**SUPPLEMENTAL/BID BULLETIN NO. 2  
For LBP-HOBAC-ITB-GS-20230703-01**

**PROJECT** : **One (1) Lot Uninterruptible Power Supplies for LANDBANK  
Data Center Aurora Boulevard**

**DATE** : **September 8, 2023**

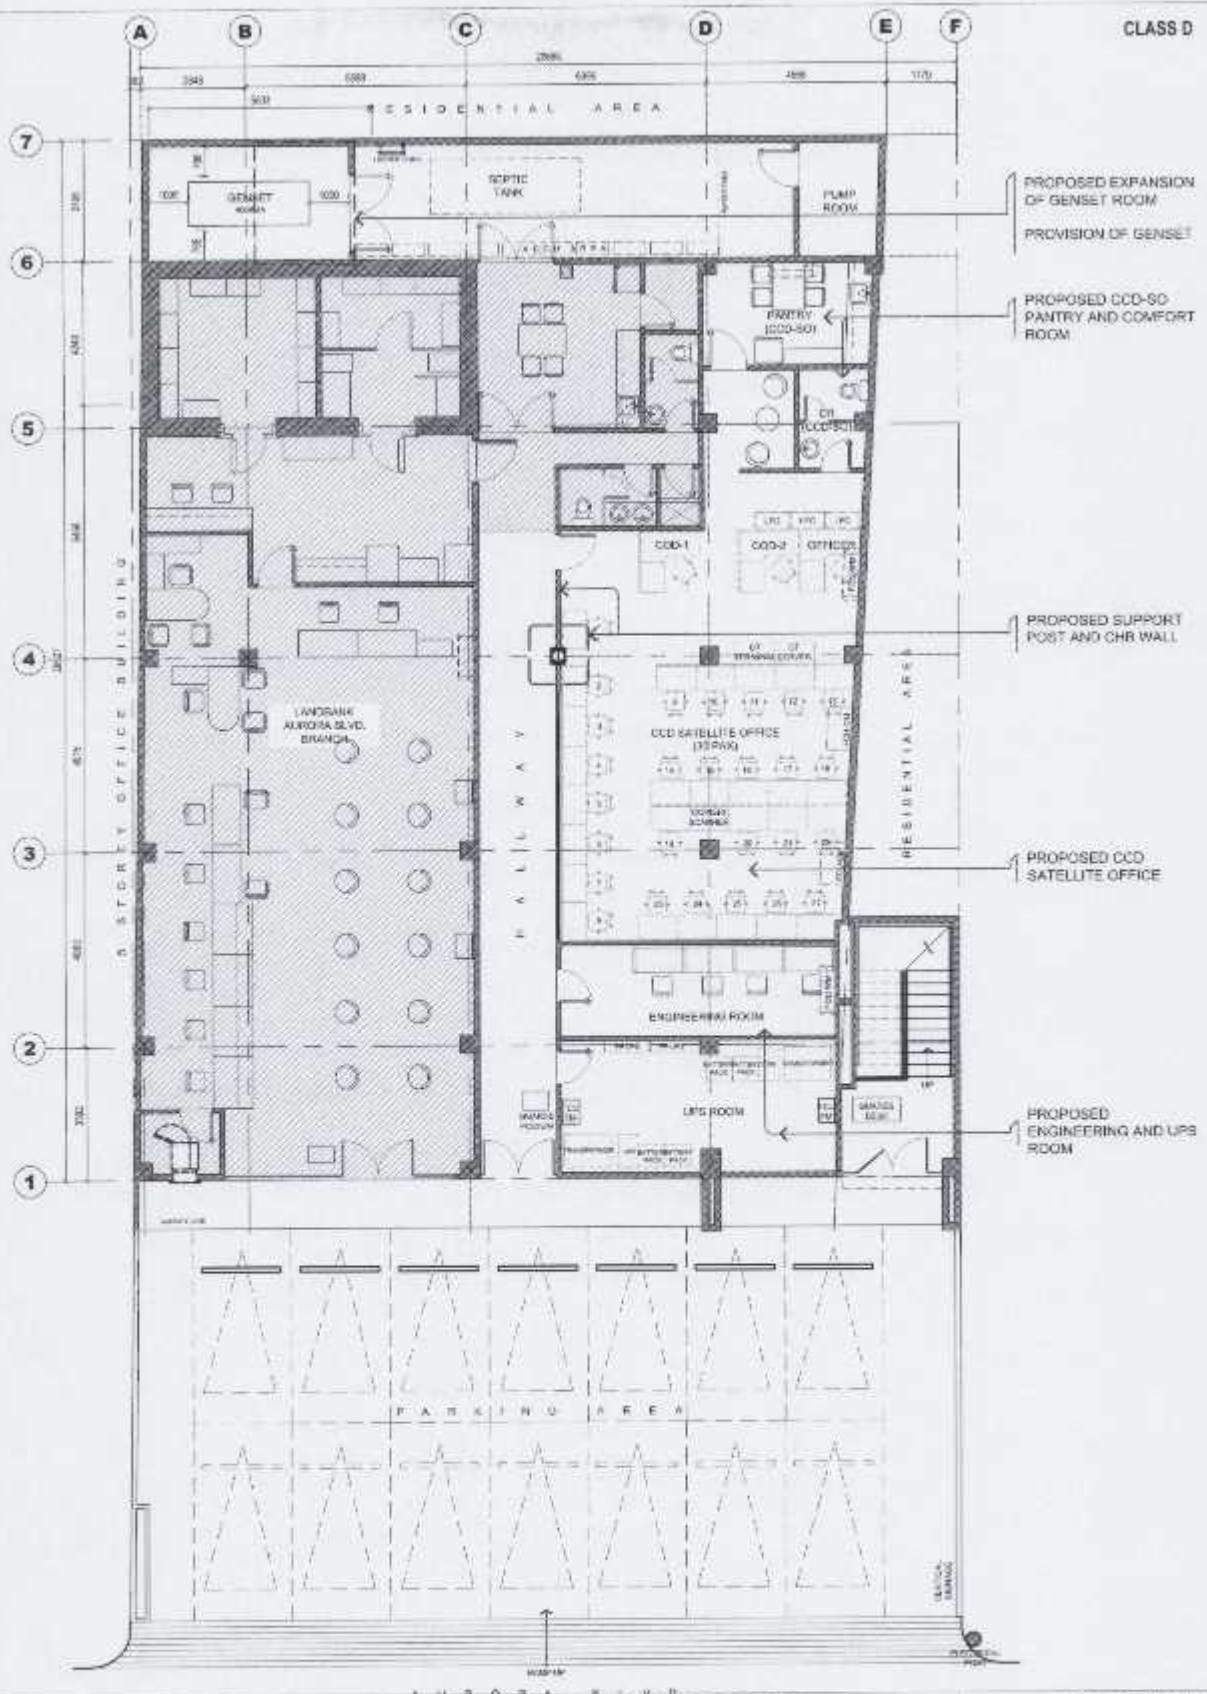
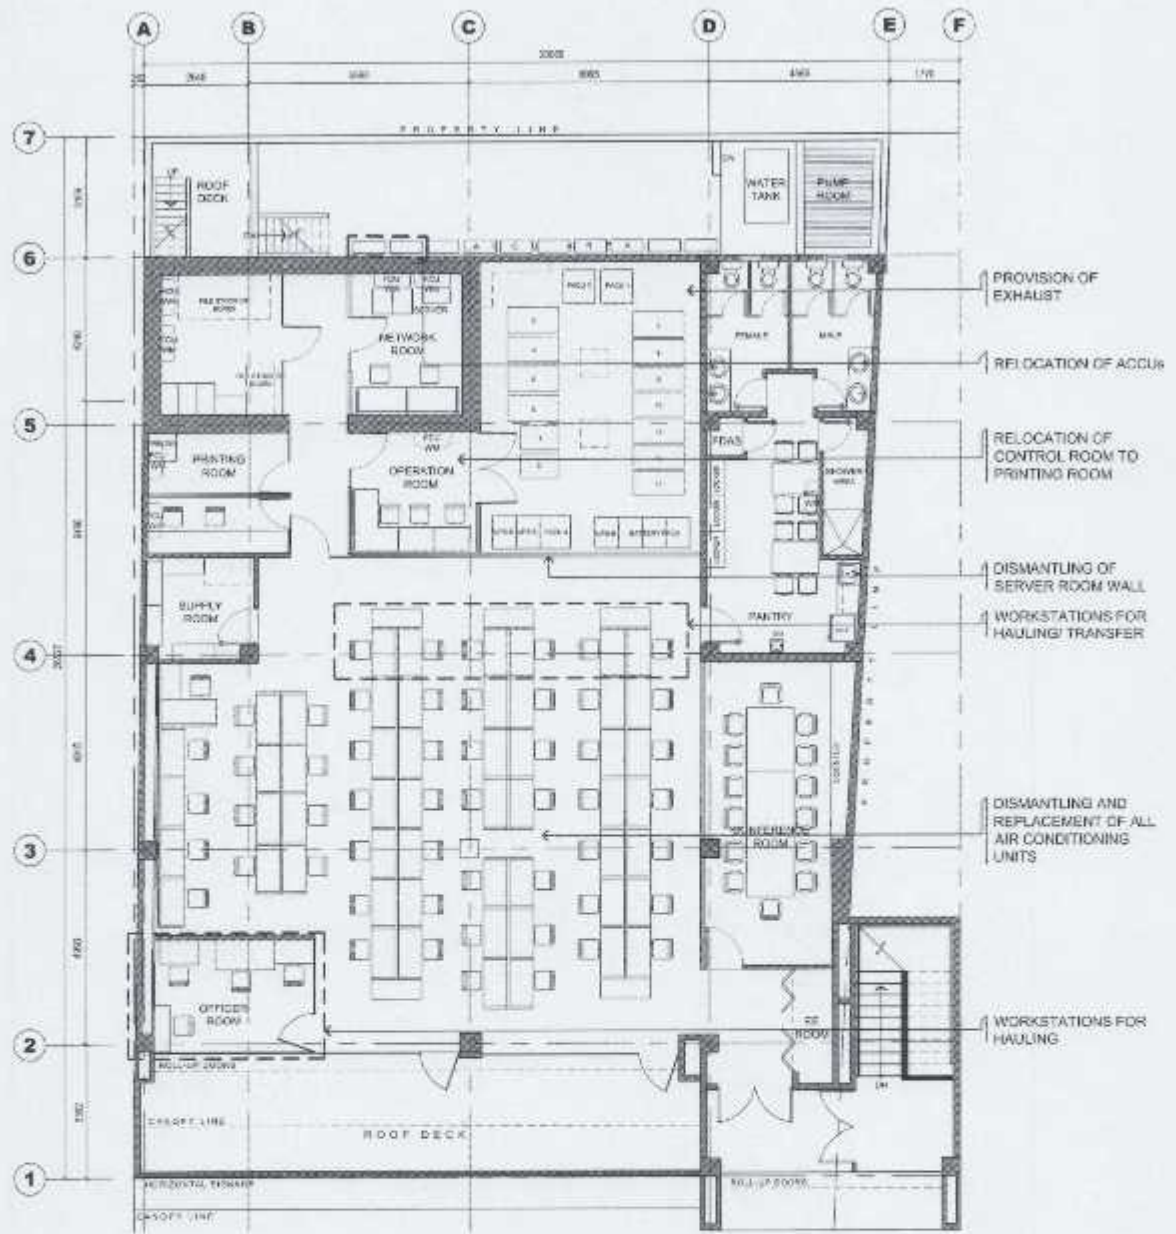
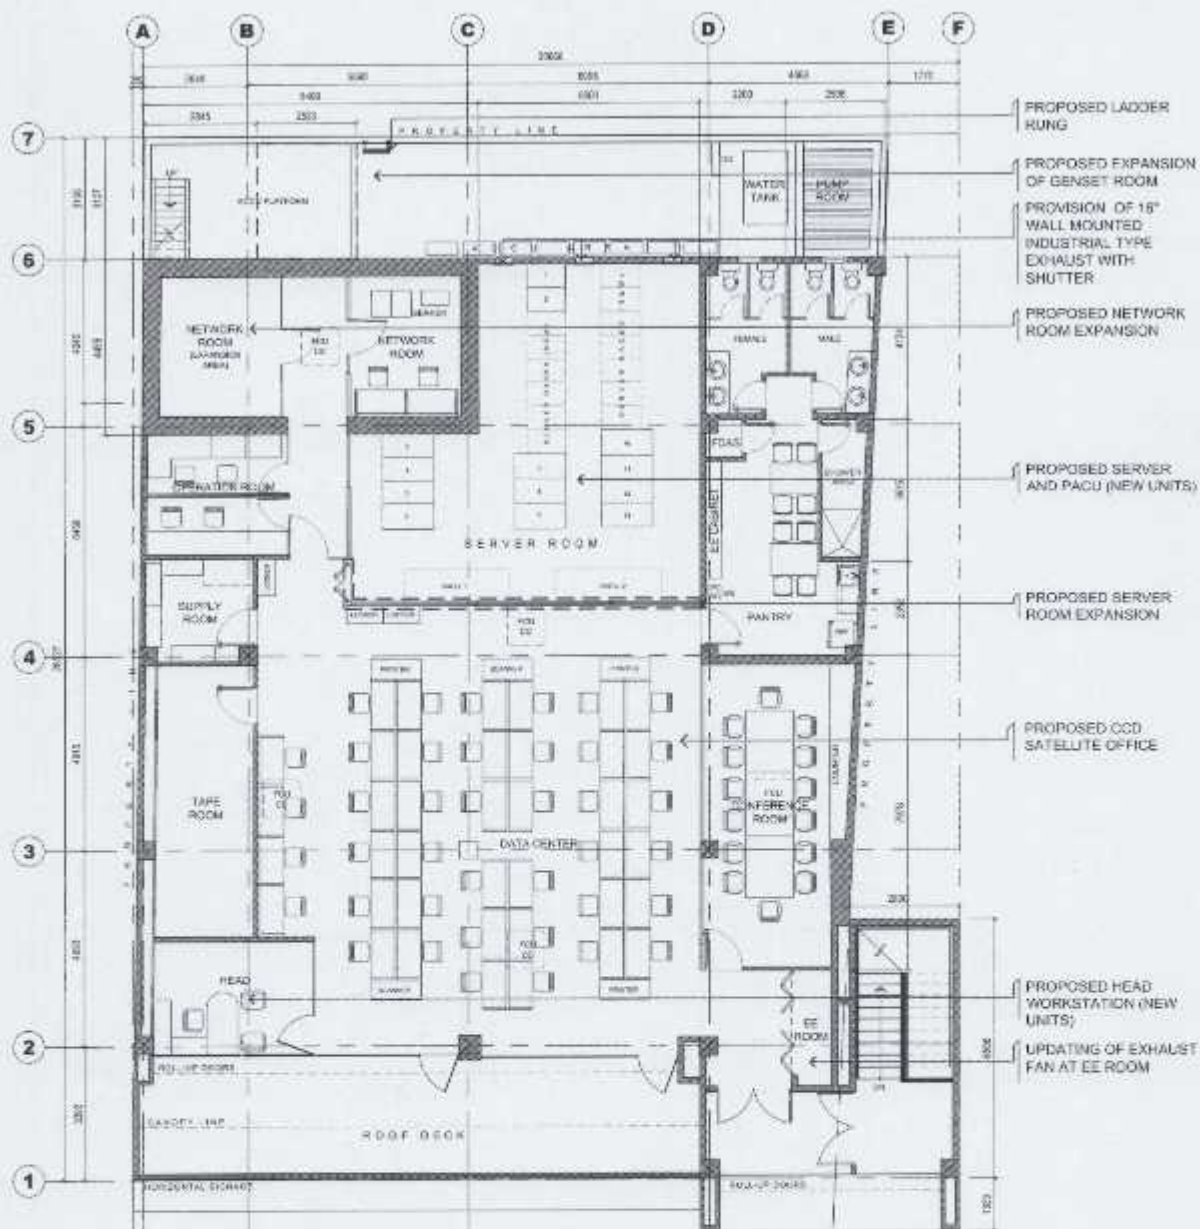
9.		May we request for the room layout?	Attached room layout
